Staff Report & Recommendation

Design Review Board

SUBJECT: DRB17-0202
6300 North Bay Road – Single Family Home

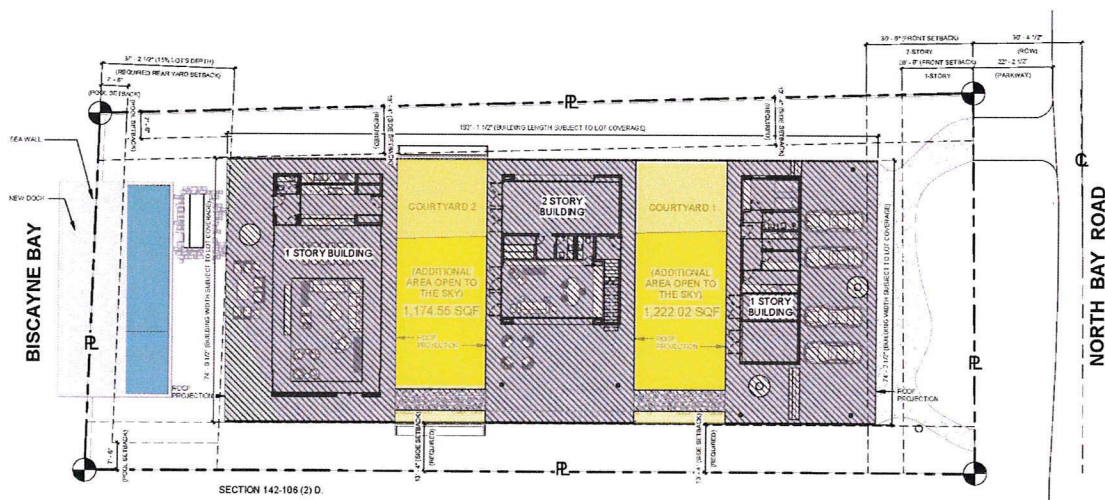
Further analysis of the lot coverage calculation also takes into account outdoor covered areas that are open on at least two sides. The Code exempts those covered areas that area attached to main building and project 10 feet or less from being included in the overall lot coverage calculations. The areas highlighted below illustrate the nearly 3,520 SF of covered open areas that, in addition to uncovered outdoor area, constitute the excessive lot coverage of 53%.

If the total outdoor area of nearly 7,000 SF were to be subtracted out of the lot coverage for analysis purposes, the design proposal would be requesting a lot coverage of 25.7%--nearly 5% below the zoning allowance for two-story structures.
